STAFF MEMO

Subject: **SD2019-02 - Milford DG Series, LLC, for the property located at Tax Map 6 Lot 14.** Minor Subdivision Application to subdivide Tax Map 6 Lot 14 to create one additional lot totaling approximately 1.22 acres within the Integrated Commercial – Industrial Zoning District.

**Re: Proposed Retail Building Development
30 Wilton Road, Milford, NH – Map 6, Lot 14
Response to Minor Subdivision Application Community Development / Planning Comments**

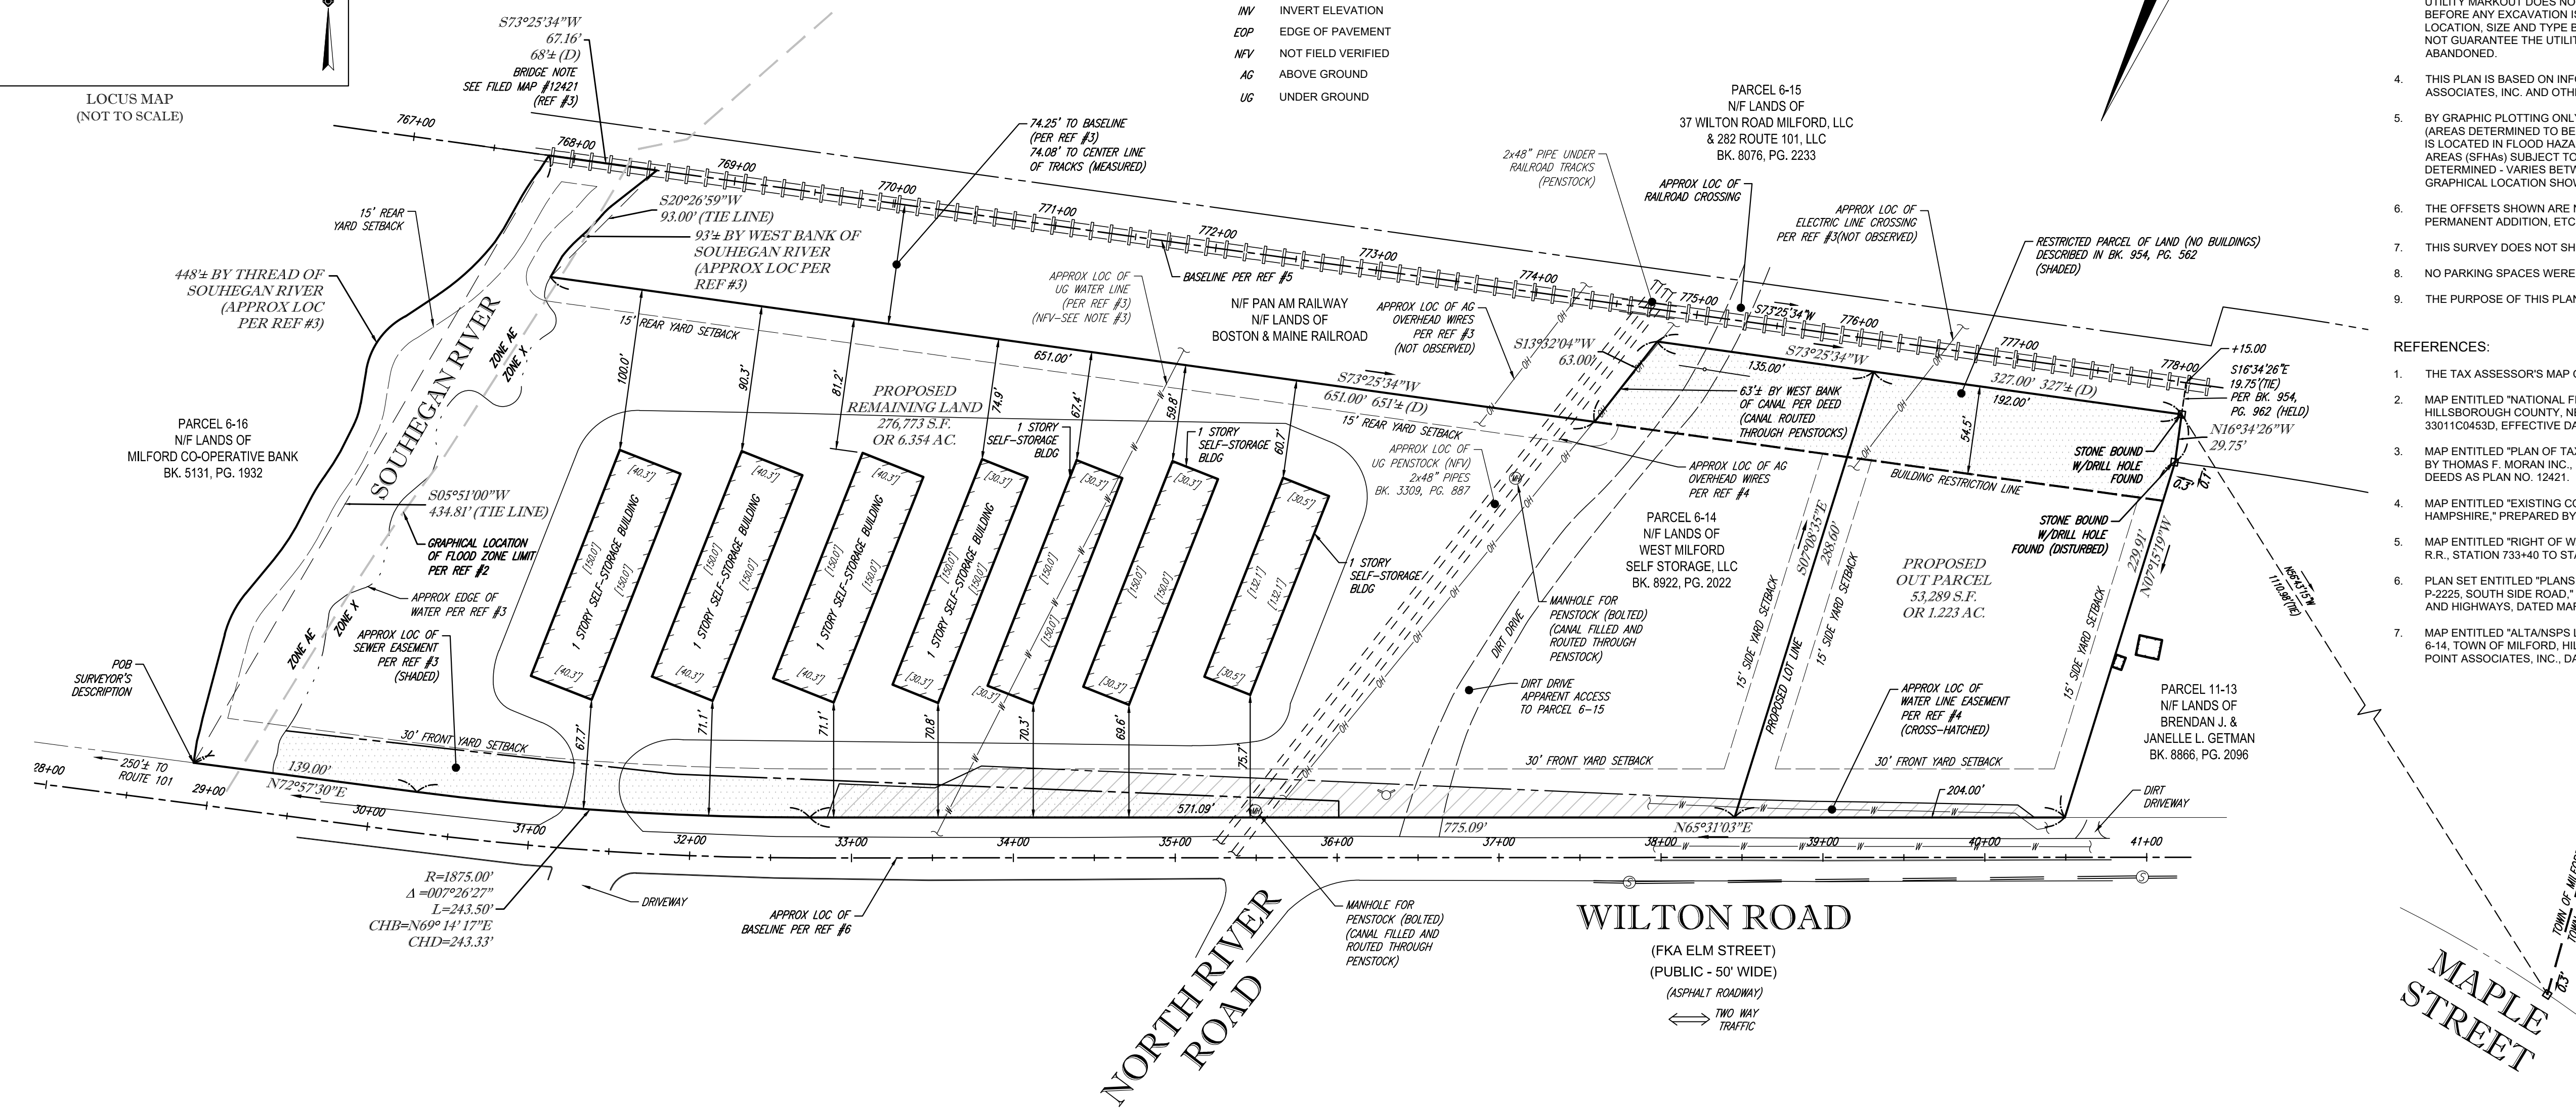
1. Subdivision Plan, Sheet 1. A note shall be added to the plan stating that prior to the signing of the plan, all monumentation shall be set and noted on the plan or a security be provided to the Town to cover the cost of monumentation.

2. Subdivision Plan, Sheet 1. The plan should be revised to identify/label both Map 6 Lot 14 and the proposed lot. Staff recommends labeling the proposed new subdivided lot, Map 6, Lot 14-1.

3. Subdivision Plan, Sheet 1, Note 9. Please relabel Note 9 to Note 1 and insert as first note and renumber accordingly.
4. Subdivision Plan, Sheet 1, Note 2. Please revise note to read as follows:
Milford Tax Map 6, Lot 14 = 330,062 Square Feet Or 7.577 Acres
Proposed Parcel Tax Map 6 Lot 14-1 = 53,289 Square Feet Or 1.223 acres
Proposed Remaining Parcel, Tax Map 6, Lot 14 = 276,773 Square Feet 6.354 Acres

5. Subdivision Plan, Sheet 1, Note 7. Please confirm that no wetlands exist on the property. If yes, please revise said note to state that no wetlands were observed on the property.

6. Subdivision Plan, Sheet 1. A note shall be added to the plan stating that Map 6, Lot 14-1 is subject to applicable Police impact fees.

7. Subdivision Plan, General Comment. As the subdivision relates to the concurrent site plan application, please explain the rationale for subdividing a parcel that requires relief from the Development Regulations to support the proposed scope and intensity of the retail development. What considerations were made to determine the size of the property?

- Comment 1:** *Subdivision Plan, Sheet 1. A note shall be added to the plan stating that prior to the signing of the plan, all monumentation shall be set and noted on the plan or a security be provided to the Town to cover the cost of monumentation.*

- Comment 2:** *Subdivision Plan, Sheet 1. The plan should be revised to identify/label both Map 6 Lot 14 and the proposed lot. Staff recommends labeling the proposed new subdivided lot, Map 6, Lot 14-1.*

- Response 2:** **The Subdivision Plan will be updated to identify the proposed lot and remaining land as requested.**
- Comment 3:** *Subdivision Plan, Sheet 1, Note 9. Please relabel Note 9 to Note 1 and insert as first note and renumber accordingly.*

- Response 3:** **The Subdivision Plan will be updated to renumber the notes as requested.**
- Comment 4:** *Subdivision Plan, Sheet 1, Note 2. Please revise note to read as follows:
Milford Tax Map 6, Lot 14 = 330,062 Square Feet Or 7.577 Acres
Proposed Parcel Tax Map 6 Lot 14-1 = 53,289 Square Feet Or 1.223 acres
Proposed Remaining Parcel, Tax Map 6, Lot 14 = 276,773 Square Feet 6.354 Acres*

Comment 5: *Subdivision Plan, Sheet 1, Note 7. Please confirm that no wetlands exist on the property. If yes, please revise said note to state that no wetlands were observed on the property.*

Comment 6: *Subdivision Plan, Sheet 1. A note shall be added to the plan stating that Map 6, Lot 14-1 is subject to applicable Police impact fees.*

Comment 7: *Subdivision Plan, General Comment. As the subdivision relates to the concurrent site plan application, please explain the rationale for subdividing a parcel that requires relief from the Development Regulations to support the proposed scope and intensity of the retail development. What considerations were made to determine the size of the property?*

- Response 1:** **A note will be added to the Subdivision Plan stating that proposed boundary monumentation is to be set prior to signing of the plan or a security provided.**

- Response 4:** **The Subdivision Plan will be updated to modify Note 2 as requested.**

Response 5: **The Subdivision Plan will be updated to modify Note 7 as requested.**

Response 6: **A note will be added to the Subdivision Plan stating that Map 6, Lot 14-1 is subject to applicable Police impact fees, as requested. Please provide requisite fees such that same can be coordinated with Applicant.**

Response 7: **As discussed with the Planning Board at their January 22, 2019 hearing, the site layout has been designed to allow for on-site circulation of traffic and delivery vehicles while respecting encumbrances associated with the existing land, including limited lot depth and a portion of land at the rear of the parcel restricted by the railroad. Alternative layouts were considered, however they necessitated additional depth that was unavailable to the project or large areas of land on Map 6, Lot 14 that were not practicable for the overall development of same.**
